**Subject** ▶ Change of Noise Suppressor and Field

**For Models** ▶ JN1600 (Nibbler), JS1600(Shear)

▶ Current	▶ New
Noise Suppressor		
Field

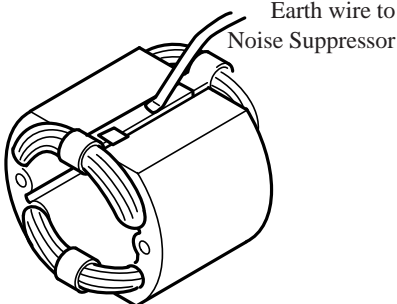
**Description** ▶ As illustrated below, Noise Suppressor and Field have been changed.

; Please, cut and insulate the earth wire of Noise Suppressor, if you change Field from the current to the new.

; Please, cut and insulate the earth wire of current Field, if you change Noise Suppressor from the current to the new.

Item No.	Current part		Q'ty'	I/C	New part		Q'ty	
15	FieldAss'y 240V 528614-8		1	<=	FieldAss'y 240V 527067-8		1	To UK & New Zealand (240V)
39	Noise Suppressor 645169-9		1	<=	Noise Suppressor 645105-5		1	To France,Reunion, Russia,Spain,Algeria, the Netherlands, Germany,Austria, Norway,Italy, Sweden,Finland and the Republic of South Africa (220V)
	Connector 2-SD 654509-0		1					
15	FieldAss'y 220V 528623-7		1	<=	FieldAss'y 220V 527066-0		1
